**Historic Review  
Staff Report and Recommendation  
Revised**

- FILE NO.:** GLUA 22-00031: HR-22-00011 resubmission for a full ADA ramp modification of HR 20-00001
- 1<sup>st</sup> HEARING DATE:** September 27, 2022 Historic Review Board Hearing  
Virtual

- LOCATION:** 1020 5<sup>th</sup> Street  
Oregon City, OR 97045  
Clackamas County Map 2-2E-31DA-10900
- REQUEST:** Exterior modifications to HR 20-01 resubmission for a full ADA ramp with modifications (Revised Metal Design) *Revised 120-day Deadline March 1, 2023*

Figure 16 -Proposed uphill side ramp approach study (HR 22-0011)

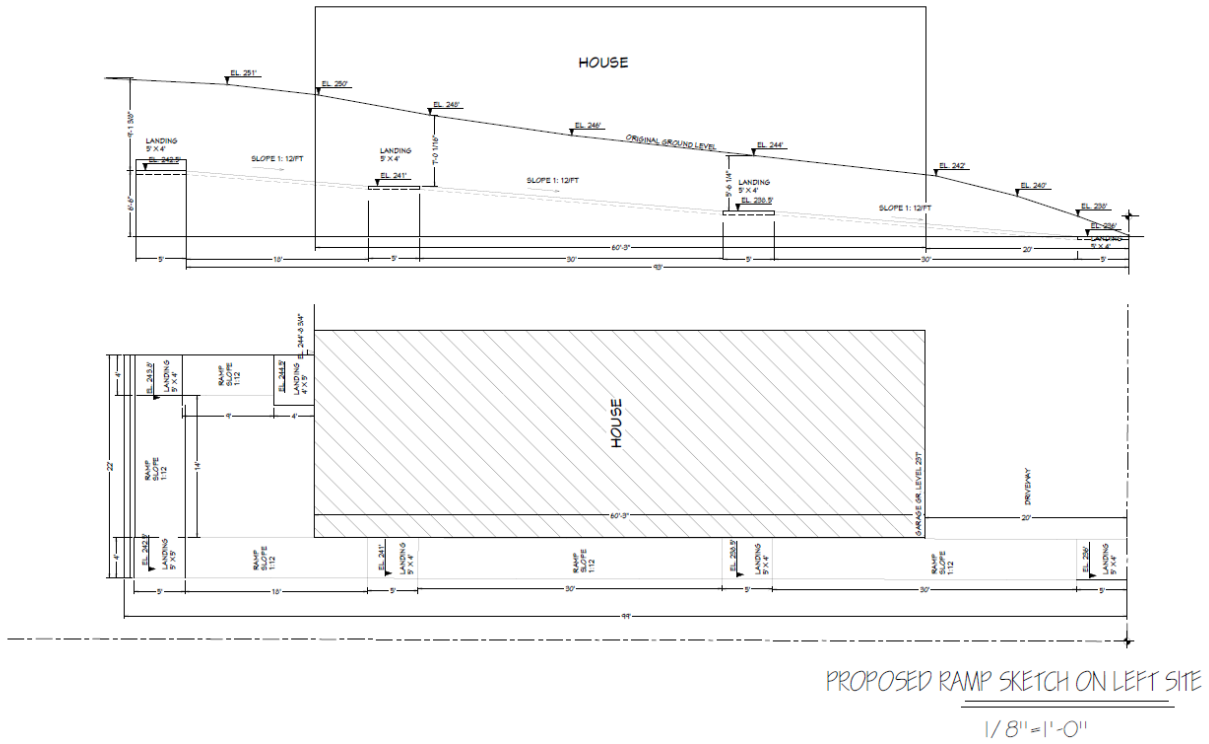
**HR 22-00011 Applicant's Response:**The Applicant provided a one-page slope analysis (figure 19) but did not provide narrative findings as to why this approach is not feasible, cost information, ramp size, and potential impact on the house or McLoughlin Conservation District. Erin Ward, Heritage Consulting Group, provided the following information: *The Applicant explored the potential of constructing the exterior ramp at several different locations around the building. The southeast side of the building cannot be used as the grade of the topography does not meet the code requirements for rise of the ramp. Additionally, the proposed ramp provides ADA access to the first floor office space as well as the second floor residential space and the first floor entrance is located on the opposite side of the building. As such the current proposed design provides full ADA access to the interior in a location that is facing the rear of the building and is the least visually intrusive to the surrounding District.*

**Staff's Findings:** At the October 25, 2022 HRB meeting, Johns Delson provided background about the rise over run calculations and indicated that even the upslope side of the building would not meet ADA-approved grade without further excavation towards the front and new retaining walls. The rise-over-run slope calculations would also require a ramp in the rear to get to the backdoor. As this site is located within the Geologic Hazard Overlay District, any additional upslope excavation would require a new Type II GeoHazard Review. With this information, it is reasonable to find that the upslope ADA ramp is not feasible at this time and could require substantial retaining walls to create a lower-sloped flatter area towards the front of the lot.

Figure 16 -Revised Site Plan. \*\*\*NEW\*\*\*

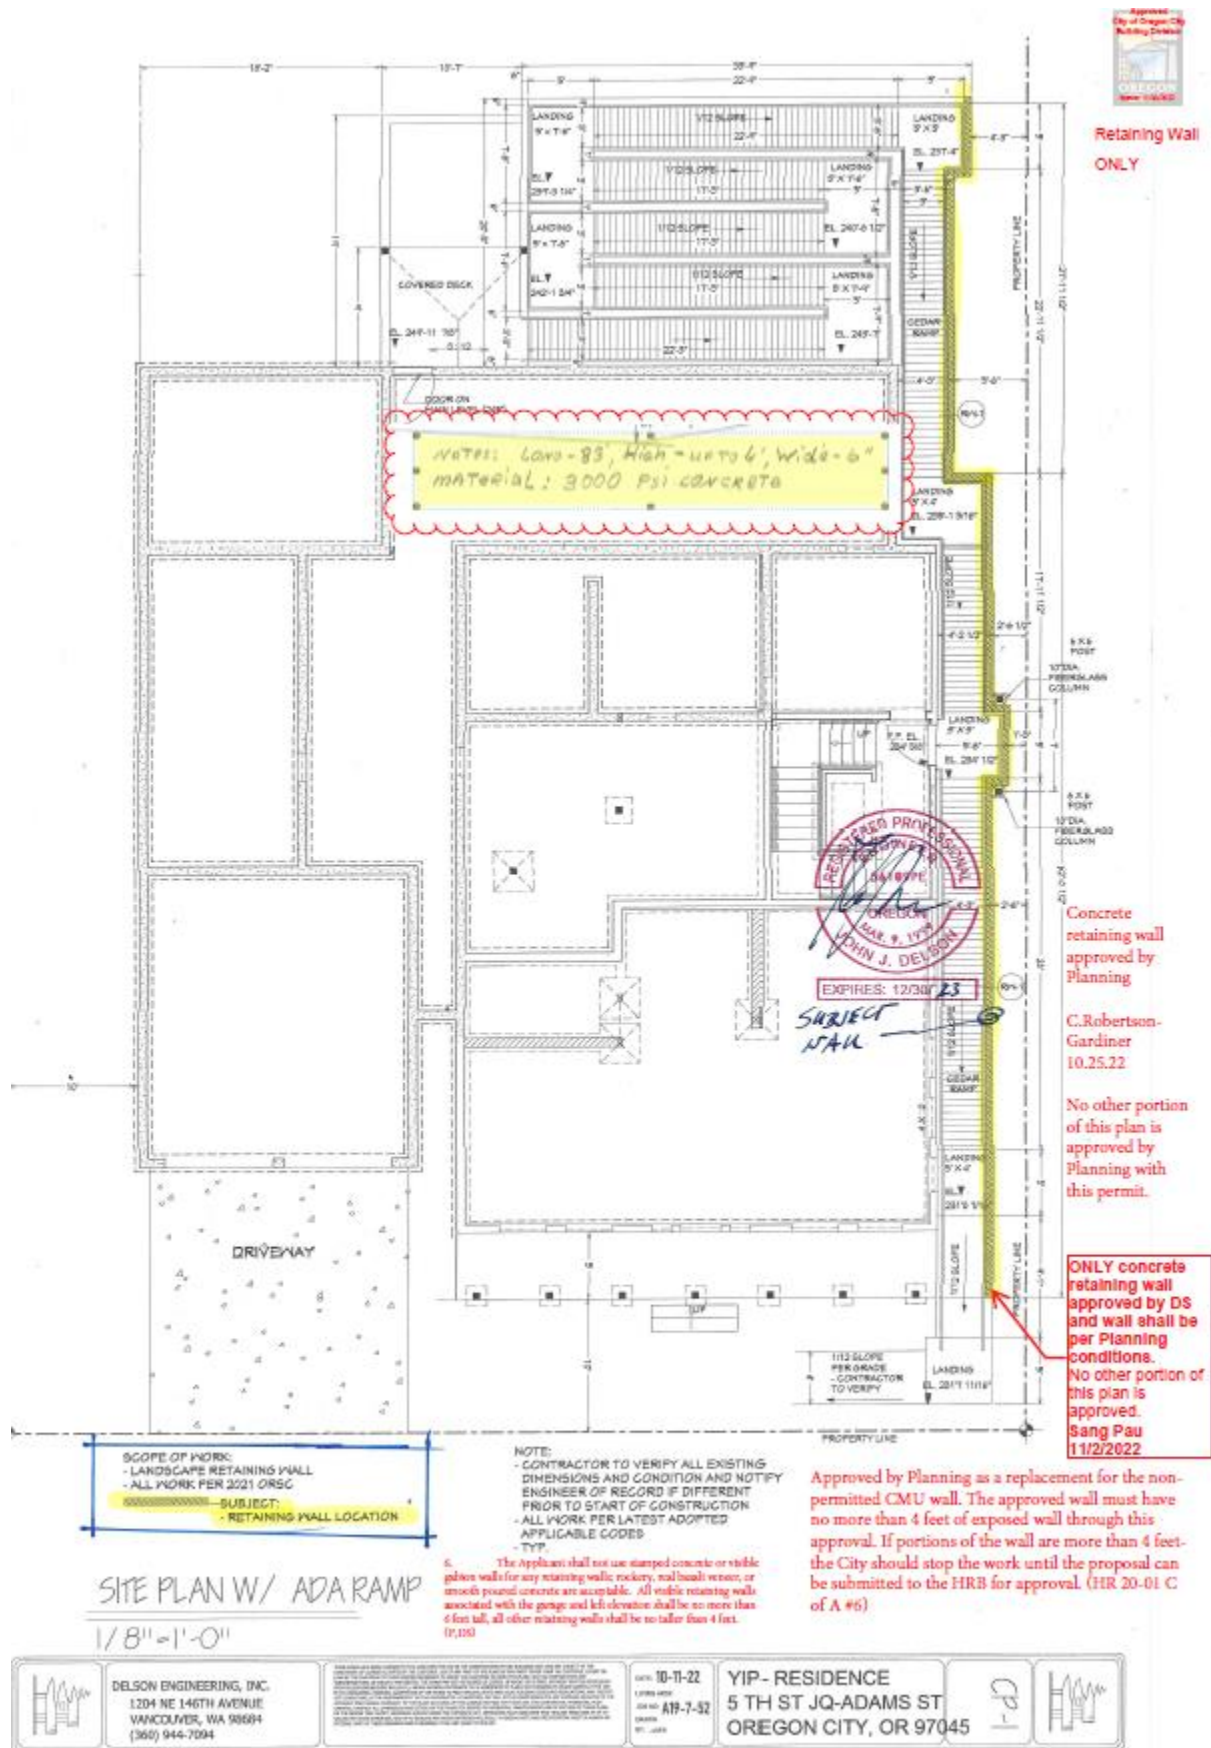
*\*note the landscape plan scale of 1 in= 20 feet does not appear to match the revised site plan. The landscape plan appears to show 3 feet and 6 feet planter beds along the side elevation. Whereas the revised site plan shows 2 feet 6 inches and 5 feet 6 inches accordingly. With space at such a premium, it is very important to ensure that both plans utilize the same scales and that the registered landscape architect can confirm that the planting choices will be successful notwithstanding a potential 6-inch reduction in the planting area.*

The landscape plan appears to show 3 feet and 6 feet planter beds along the side elevation. Whereas the revised site plan shows 2 feet 6 inches and 5 feet 6 inches, respectively. The landscape plan appears not to include the newly approved small concrete retaining wall depicted in the revised site plan. With space at such a premium, it is very important to ensure that both plans are accurate and that the registered landscape architect can confirm in writing that the planting choices will be successful notwithstanding a potential 6-inch reduction in the planting area. Recommended revisions and conditions of approval have been added at the beginning of the document to ensure that there is adequate planting space and it is monitored over the next three years

- The Applicant shall remove the highly decorative pendant lighting along the side (right) elevation and rear (if installed) and replace with simple downlighting painted to match the siding color of the house
- The landscape plan appears to show 3 feet and 6 feet planter beds along the side elevation. Whereas the revised site plan shows 2 feet 6 inches and 5 feet 6 inches, respectively. The landscape plan appears not to include the newly approved small concrete retaining wall depicted in the revised site plan. With space at such a premium, it is very important to ensure that both plans are accurate and that the registered landscape architect can confirm in writing that the planting choices will be successful, notwithstanding a potential 6-inch reduction in the planting area.

Figure 16 a/b -Landscaping Plan. **\*\*\*NEW\*\*\***

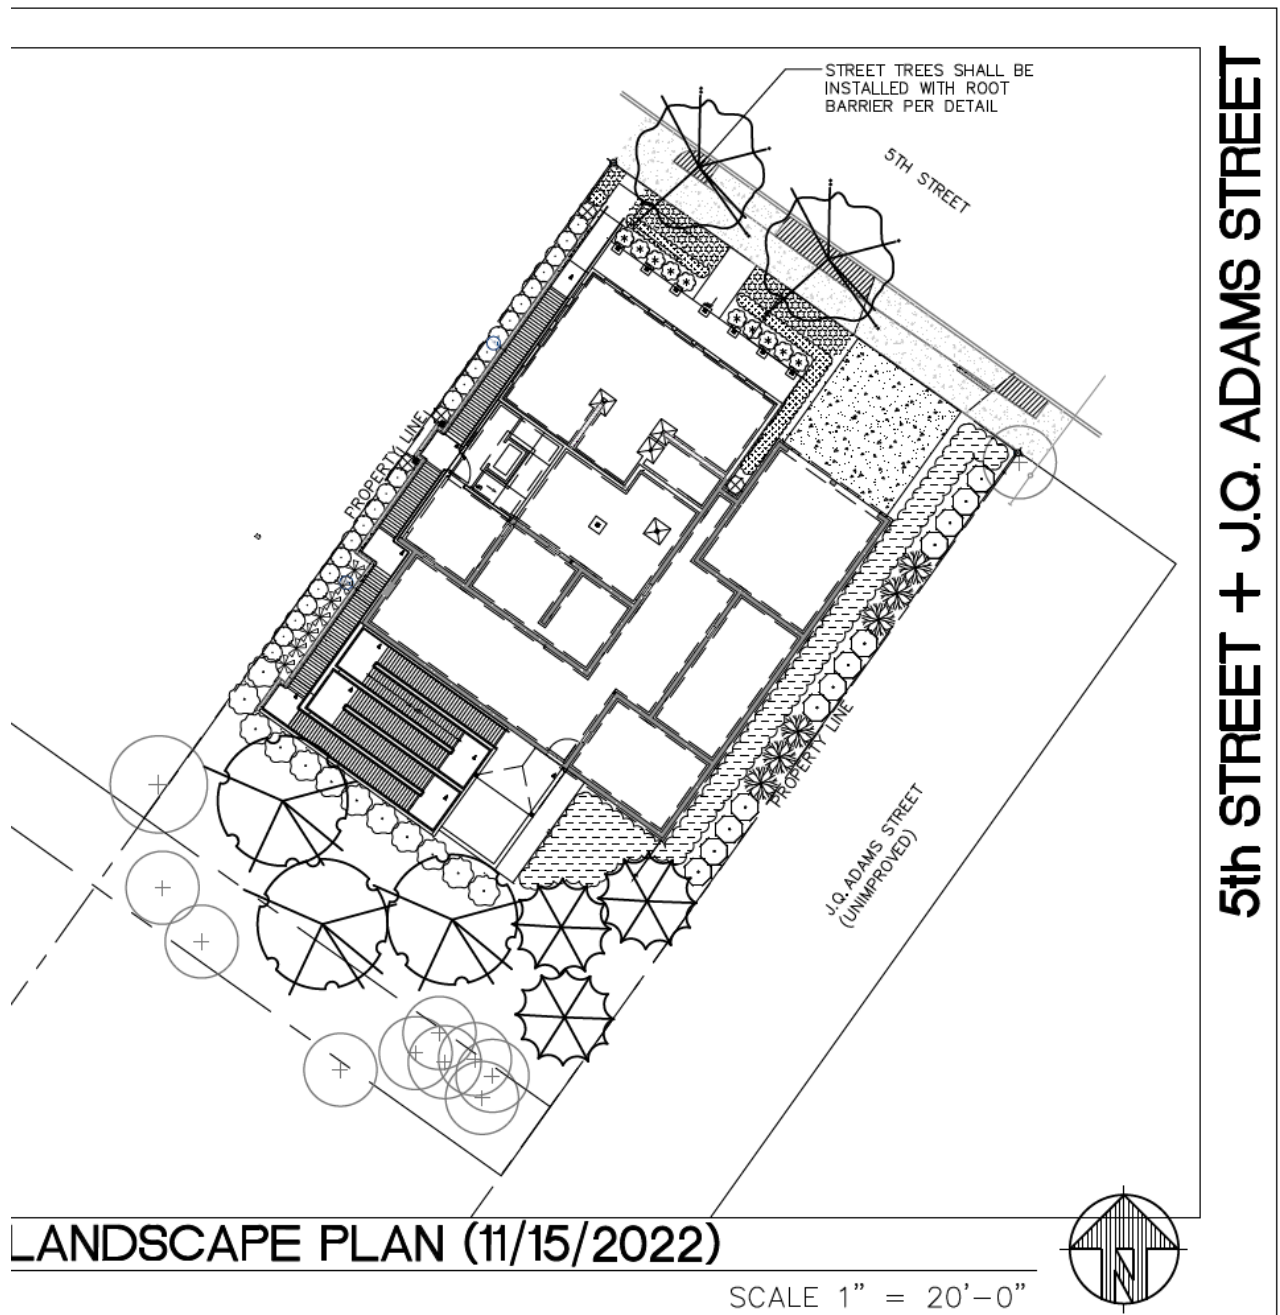
A row of 2-gallon Greenmountain boxwood (mature height 3-5 feet) is shown between the ADA ramp and the property line on the side elevation (approx. 3 feet). A row of little lime hydrangeas (mature height 6-8 feet tall) is planned to be planted behind the boxwoods towards the rear of the property line as the ADA ramp stepback. This creates an approx. 6-foot planter area for the final 1/3 of the ramp abutting the property line. Nuccio's Gem Camellias (mature height 15 feet) are planned to wrap around the rear portion of the ramp. These proposed plants do seem to provide adequate long-term screening to mitigate the massing of the ramp.

2. Prior to obtaining a full Certificate of Occupancy, the Applicant shall install the revised landscape plan associated with buffering the visual impact of the ramp from 5<sup>th</sup> Street. (Exhibit 1b). One year after obtaining a full Certificate of Occupancy, staff shall perform a site visit to verify that the plantings along the side (right elevation) buffering the ADA ramp are healthy and require replacement plantings for any dead or dying plants.

Figure 17 -Proposed rear elevation revised full ADA ramp design (HR 22-0011) **\*\* NEW METAL RAMP DESIGN \*\***

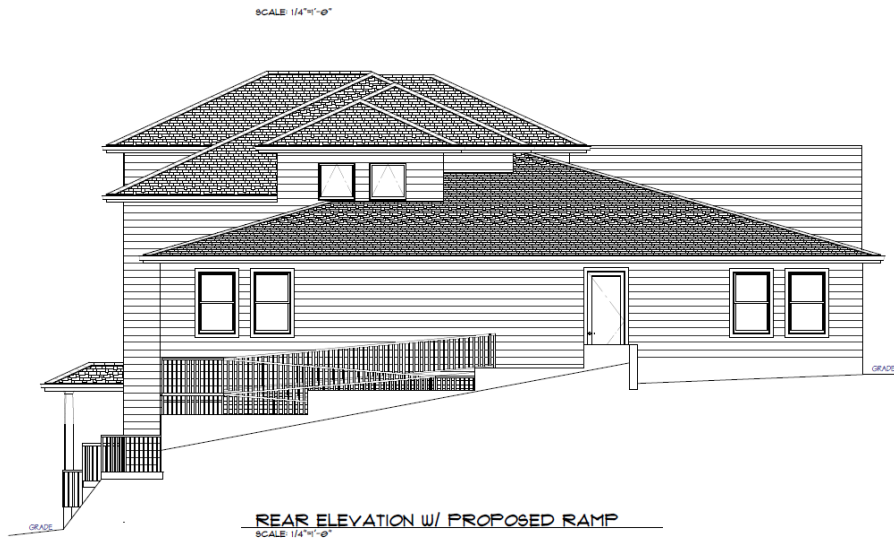
**Staff's Findings:** A wood ramp with horizontal siding may be appropriate for the smaller side entry design, but as it is extended to the rear, which was once compatible, seems to create the large mass that caused the Historic Board and the City Commission to deny the full ADA ramp. The US Department of the Interior National Park Service, Cultural Resources Division has promulgated a Preservation Brief dealing specifically with accessibility, which is attached here and may provide a suitable reference for how the City might interpret its historic standards with respect to the ADA. The brief provides examples of metal designs that are lighter and airier than the wood option. These simpler design look to hide the ramp rather than integrate it into the design of the building.

The submitted metal design utilizes a simple black powder-coated railing and a metal ramp. The ramp is supported by a concrete podium at the side door and retaining walls.

- In order to further differentiate the ramp and the house and reduce its massing on the District, the Applicant shall return at a date certain future meeting with updated elevation drawings that remove horizontal siding from all portions of the ramp structure. Exposed poured-in-place concrete and exposure of the metal structure underneath is encouraged to the extent practicable to allow it to be seen as a lighter, airier structure.
- The Applicant shall remove the rounded columns from the side door entry as rounded columns are not appropriate on a secondary entry. The side porch posts shall be simple and wood-wrapped.

Figure 18 -Proposed side (right) elevation revised full ADA ramp design (HR 22-0011) **NEW METAL RAMP DESIGN \*\***

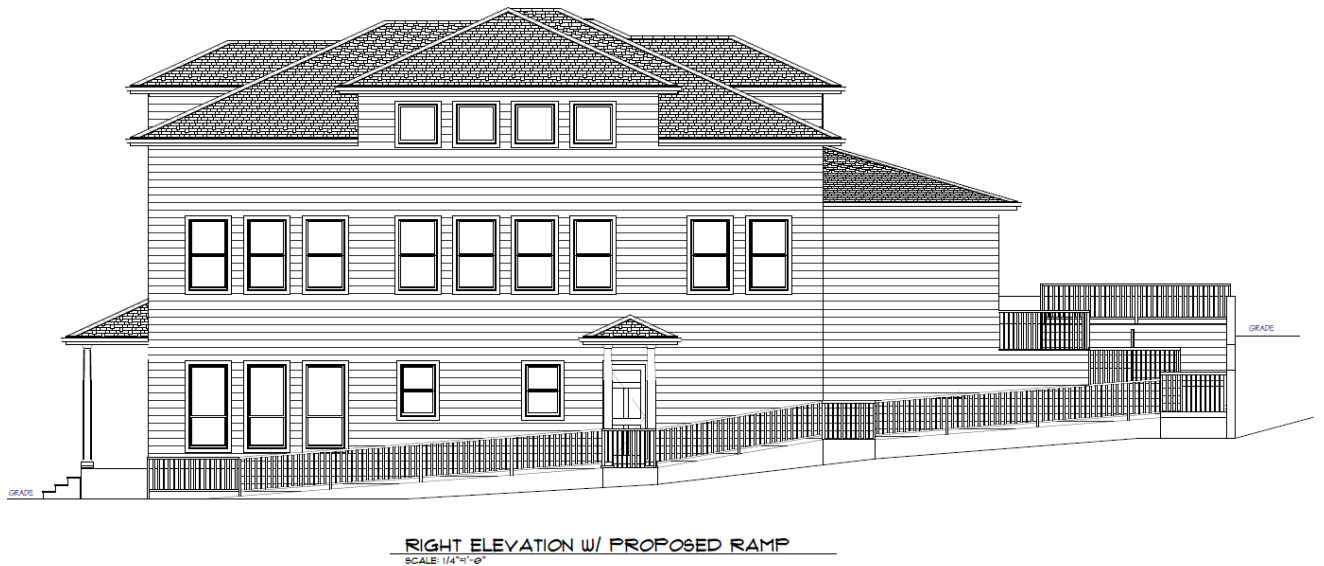
A black powder-coated metal ramp with simple railings spaced at the minimum needed to meet building code allows for the least amount of visual impact. As stated above in the staff report, metal ADA ramp railings were used in the historic Ermatinger House. They were also approved in the initial HR 20-0001 approval on the uncovered garage balcony, where wood railings would have a very short lifespan. The use of metal railings to reduce massing or address uncovered areas should be differentiated from the use of railings within traditional house architecture, such as a porch or stair railings, which the design guidelines do not recommend.
